City of Ryde Submission NEXTDC S5 Data Centre and Innovation Hub at 269 Lane Cove Road, Macquarie Park

SSD-63168959

**Submission Date: 30 August 2024
COR2023/160/2**

Figure 3: view of the development from Lane Cove Road (Source: HDR Architects)

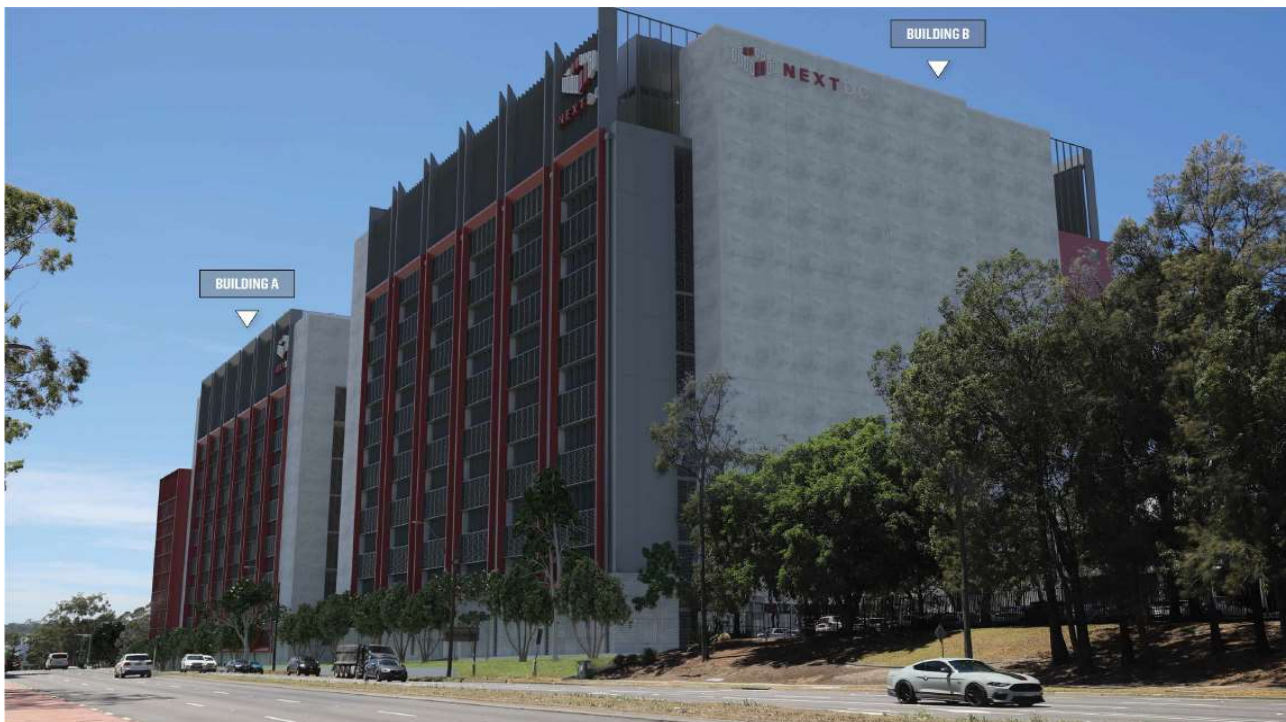
The proposal is bulky and largely impermeable. While this may be a function of the use (which Council does not support), the façade facing Lane Cove Road is bereft of activation. Glazing to internal corridors above street level contribute zero activation of the public domain. There is no

The concrete wall proposed along Lane Cove Road (shown in the renderings and western elevation) is not supported. Council will not support the concrete blast barriers fronting the public domain seen at other NextDC sites.

The colour scheme, signage, and form do little to give this important intersection a unique identity. The proponent should offer a revised design which acknowledges the importance of this intersection as a key transport and activity node in Macquarie Park. The colour scheme ought to be reconsidered to take better advantage of the orientation, visibility, and place in the Macquarie Park precinct and reduce the bulk of the proposal.

6. The proposal is mostly hostile to its surroundings, failing to recognise the changing urban environment around it and offering little to current and future neighbouring uses. The proposal appears to be designed to look as large as possible along Lane Cove Road. The repetition of vertical elements emphasises the bulk and lack of variety in the proposed form.
